PIC32MZ Graphics (DA) Family

PIC32MZ Graphics (DA) Family Silicon Errata and Data Sheet Clarification

The PIC32MZ Graphics (DA) family devices that you have received conform functionally to the current Device Data Sheet (DS60001361H), except for the anomalies described in this document.

FIGURE 1: Posc CRYSTAL CIRCUIT

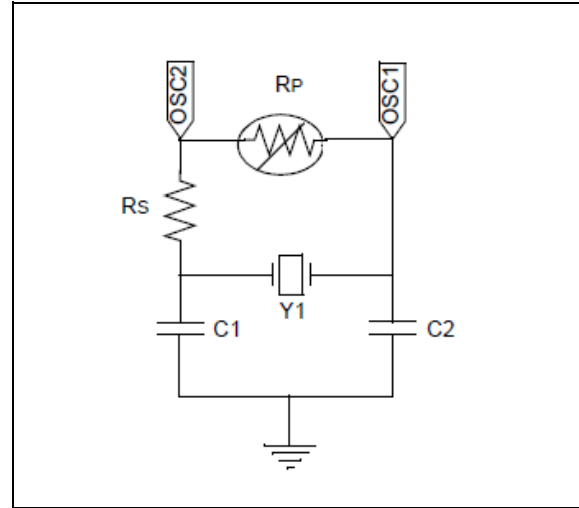
The POSC has been tested in a normal power-up sequence and supports specific crystal operation.

The Primary Oscillator (POsc) has been characterized to operate at 8 MHz and 12 MHz when the circuit shown in [Figure 1](#) is implemented, and the operating conditions listed in [Table 3](#) are met.

Crystal Frequency (See Note 1)	Series Resistor Rs	Posc Gain Setting POSCGAIN<1:0> (DEVCFG0<20:19>)	Posc Boost Setting POSCBOOST (DEVCFG0<21>)
8 MHz	2 kΩ	'0b00 (GAIN_0)	'0b1
12 MHz	1 kΩ	'0b00 (GAIN_0)	'0b1

Note 1: Using any other crystal frequency will require special component selection and characterization.

2: A parallel register (RP) should not be used to increase the gain of the POSC.

FIGURE 2: EXTERNAL RESET CIRCUIT

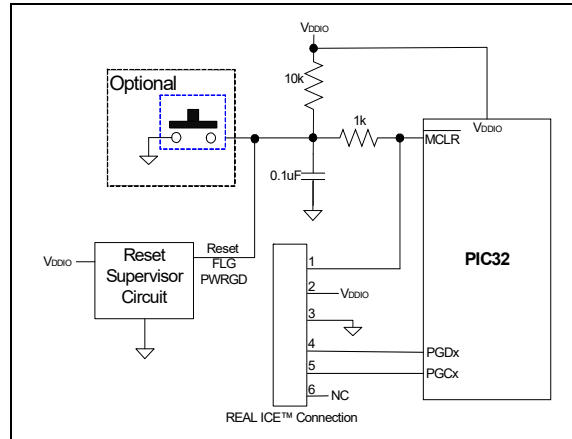
A system Reset is not generated on a BOR event ($V_{PORIO} < V_{DDIO} < V_{BORIO}$). This will stop system clocks with all the I/O pin functions frozen in the present state until either V_{DDIO} falls to V_{PORIO} or $V_{DDIO} > V_{BORIO}$.

Reset device using a \overline{MCLR} pin through an external reset supervisor/monitor is shown in Figure 2. Set the SMCLR (DEVCFG2<15>) configuration bit to '0', which makes the \overline{MCLR} to act as a POR Reset instead of a normal system reset.

- Minimum Reset trip voltage of the external supervisor should be $V_{BORIO} (Max) + 0.5V$.
- The external reset supervisor/LDO output going to \overline{MCLR} should have an open drain output to not interfere with the MPLAB programming/debug tools.

When this work around is implemented, the minimum V_{DDIO} operating voltage of the application needs to be above the reset supervisor maximum trip voltage + 0.2V, where 0.2V compensates for variation in the external reset supervisor voltage.
